**IFB No. 17-26 Eisenhower Middle School HVAC and Roof Access Renovations**

**RE: ADDENDUM NO. 1**

Changes to Bidding Documents Dated January 13, 2017

PROJECT: EISENHOWER MIDDLE SCHOOL  
HVAC AND ROOF ACCESS RENOVATIONS  
ROCKFORD PUBLIC SCHOOLS 205  
ROCKFORD, ILLINOIS

ISSUED FOR:	DATE:
PROJECT NUMBER	25108
SHEET NUMBER	A4.2
DRAWN	APPROVED

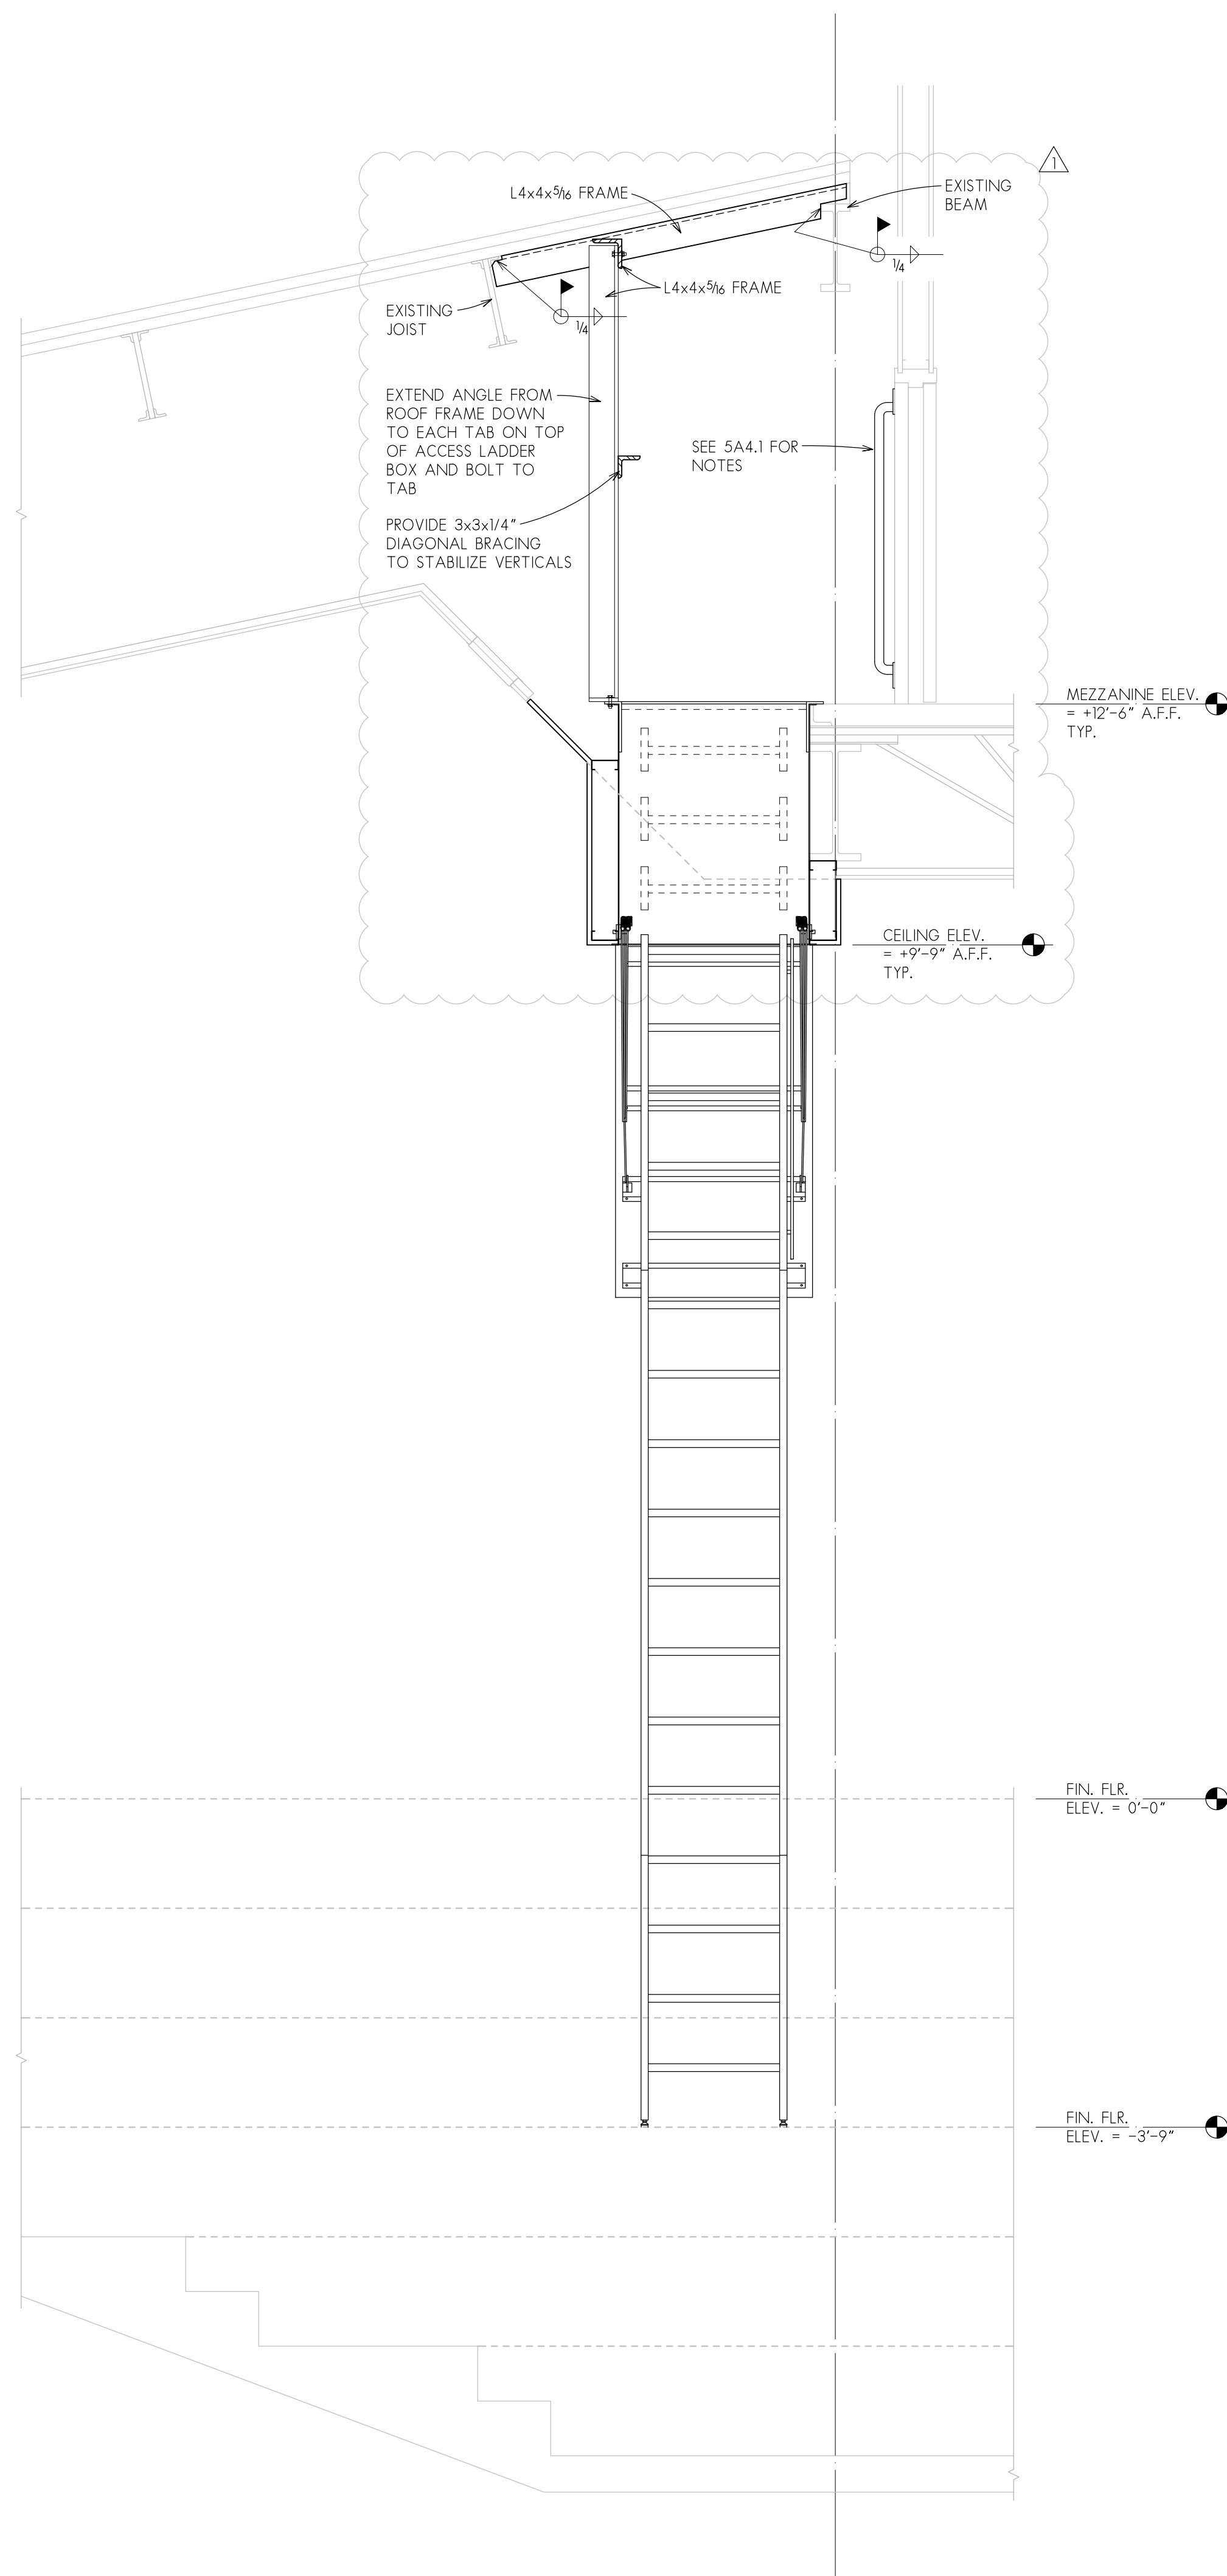
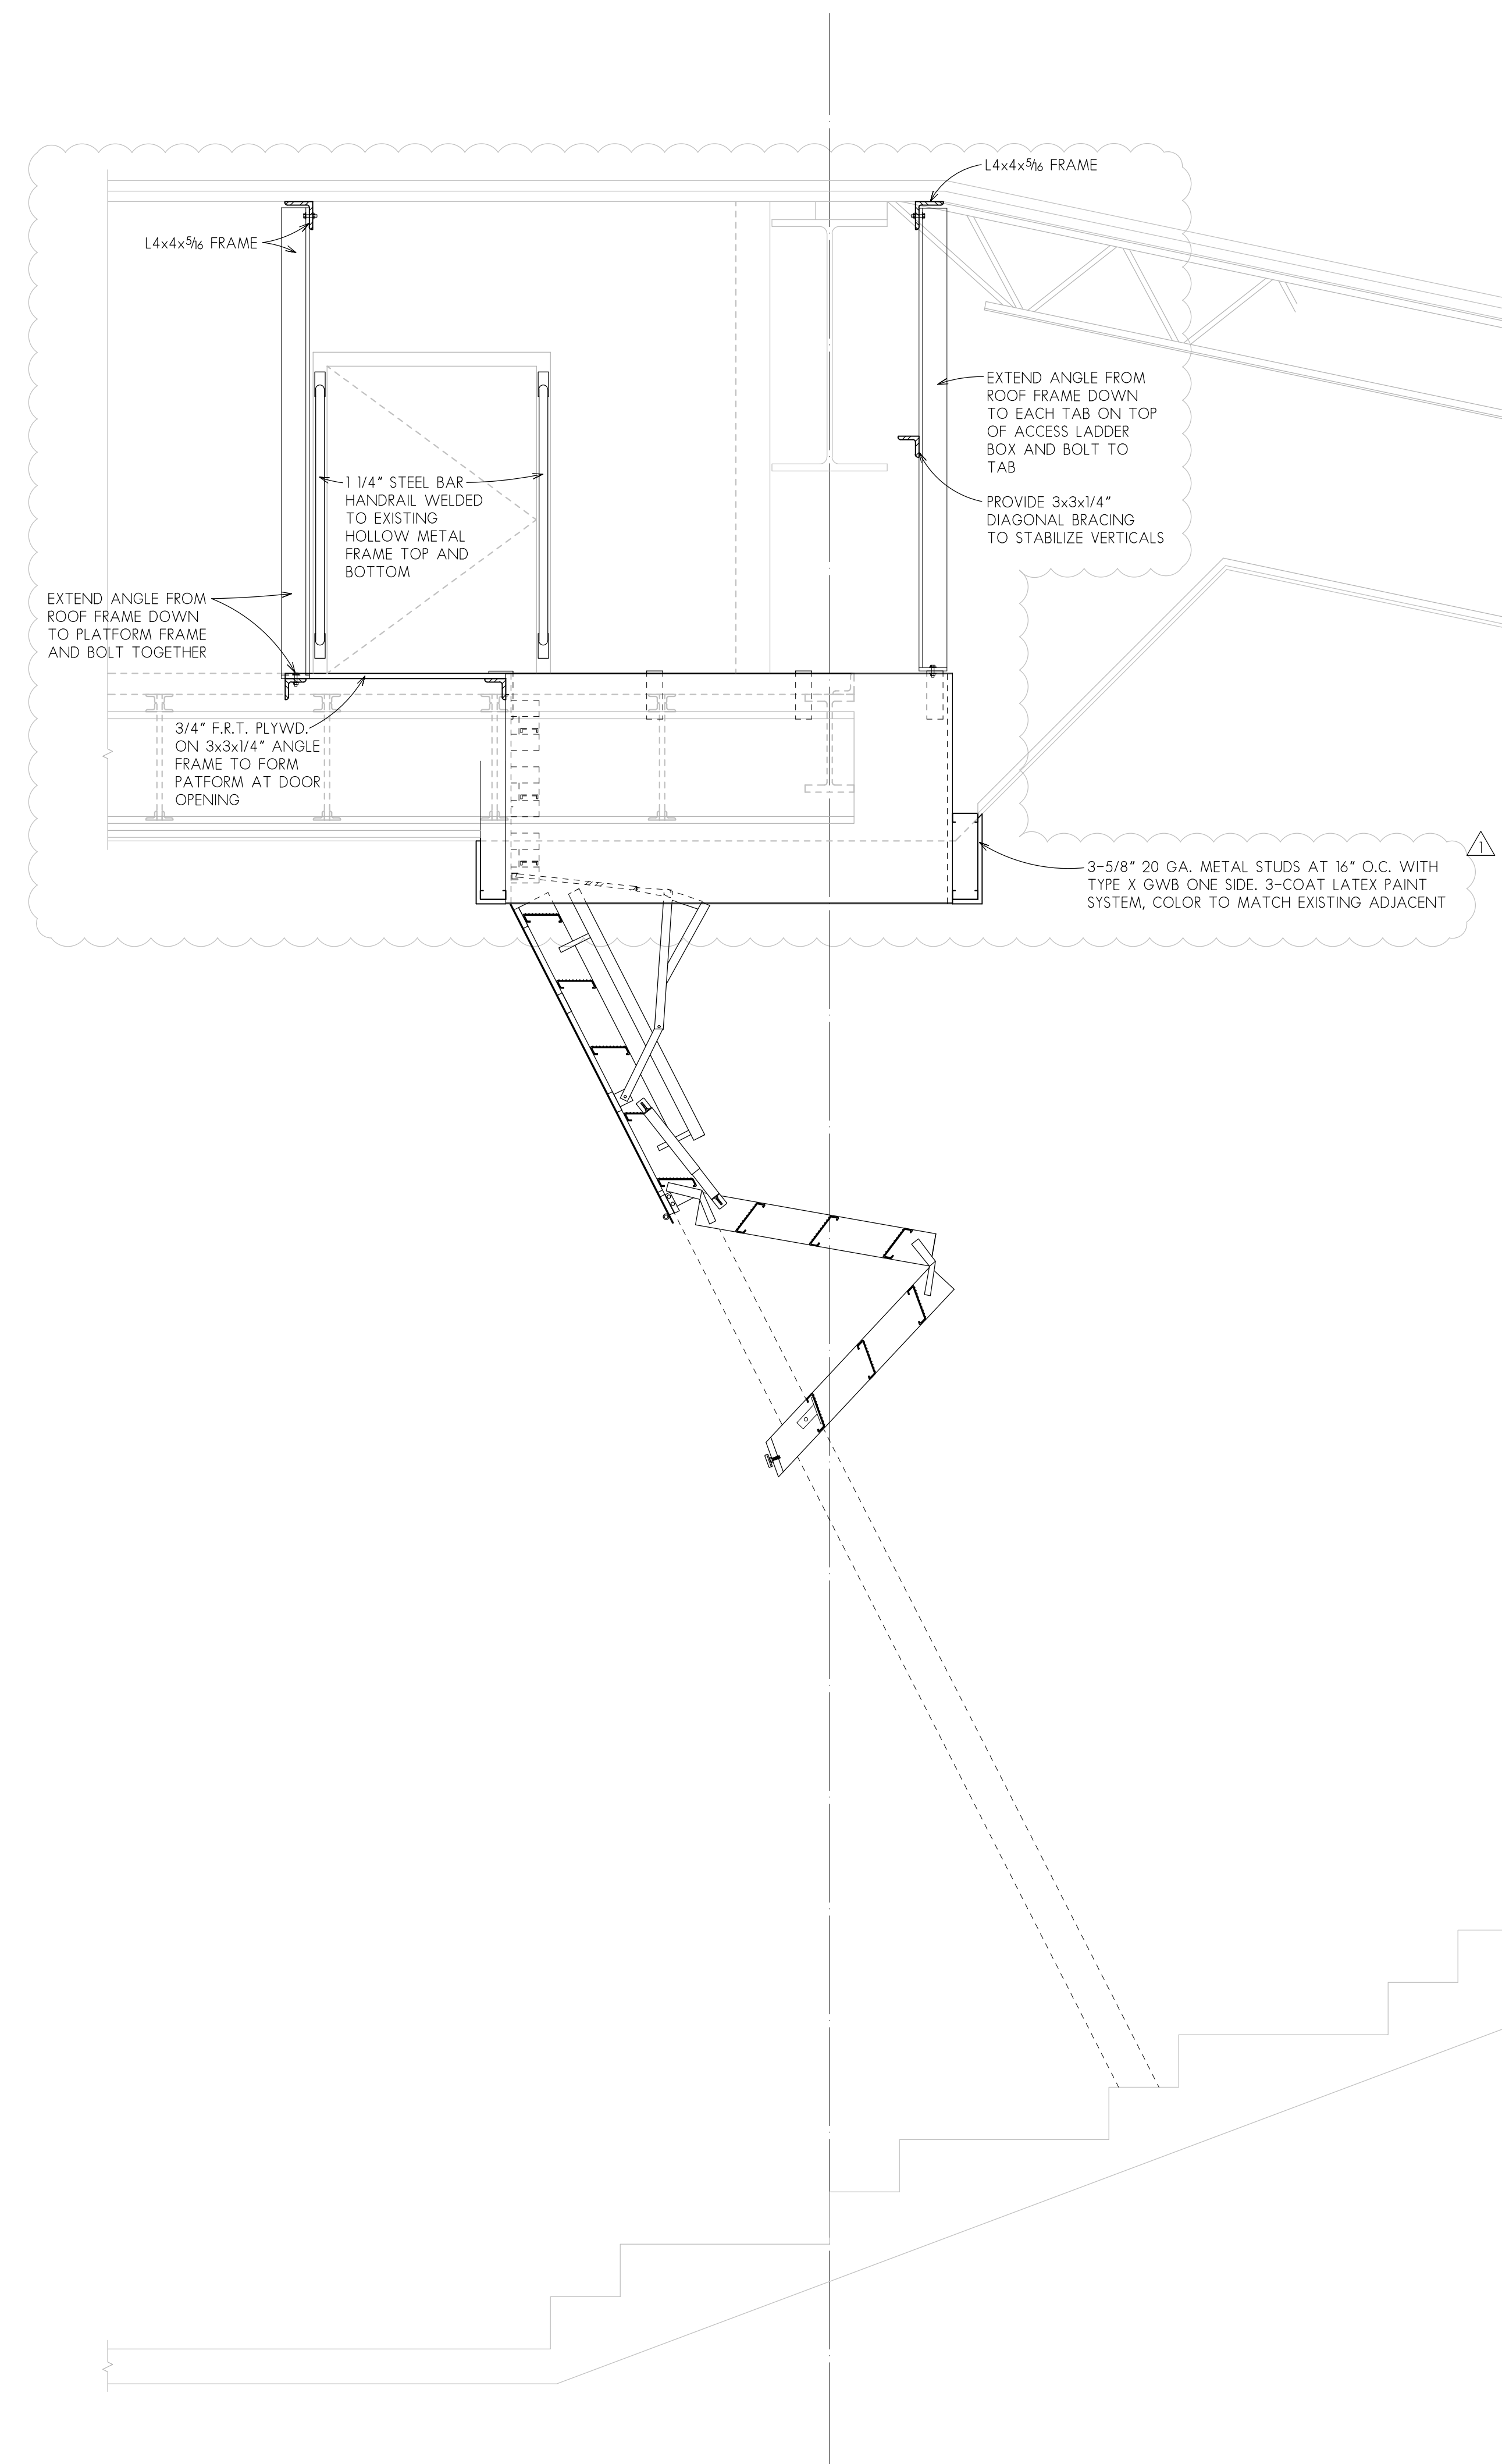
5. There is steel stud framing and drywall work shown for ladder number 6. Please provide specification for required materials. Is there patching required for the other six access ladders? If so, what is the existing construction (steel studs, drywall, acoustical, steel joists, concrete, etc).? Are structural member cut, shoring, etc. required?

**Yes, all steel ladders, safety cages, steel handrails and bar grating are all to receive galvanized finish. They are also to be field painted.**
7. Painting Specification (099100) states to paint steel ladders, cages, and handrails (paragraph 1.1.A.1 & 2). The schedule only indicates paint for exterior (paragraph 3.3.A.1), but there is also interior handrails. Do the painted items not require galvanizing? There is not paint specification for new drywall.

10. The 13'-6" floor to ceiling height requires a "deep box" vs. the "deep angle" stair that is detailed. The deep box (vertical section of stairway "inside the box") is what you show for the other six(6). The 13'-6" floor to ceiling height requires that the stairway be made 22" wide in lieu of the standard 30". This should be clarified or the other option may be to extend the framing down to "lower" the ceiling height. The "end" of the stairway is perpendicular to the doorway and ends into only what is probably open

11. The 10'-0" floor to ceiling height could allow a "deep angle" stair installed vs. the "deep box" shown. This would allow the stair to continue on an angle in lieu of having a vertical section at the top. Please clarify.

12. The stair box is shown to abut the mezzanine only at the top width (30") of the stair. There is no support for the stair box at the other three (3) sides. Will this arrangement support the stair? Is the deep box vertical section of the stair aligned with the beam placed this way to allow the box to be supported only along that edge?

**Refer to attached re-issued sheet A4.2. Some patching may be required for the access ladders. No structural members are to be cut, some shoring may be required for existing ceiling.**

**Yes, all steel ladders, safety cages and steel handrails are to be painted. They are also to be shop galvanized. See note on re-issued sheet A4.2 on paint for new drywall.**

***Refer to drawings A4.1 and A4.2.***

***Refer to drawings A4.1 and A4.2.***

***Refer to drawings A4.1 and A4.2***
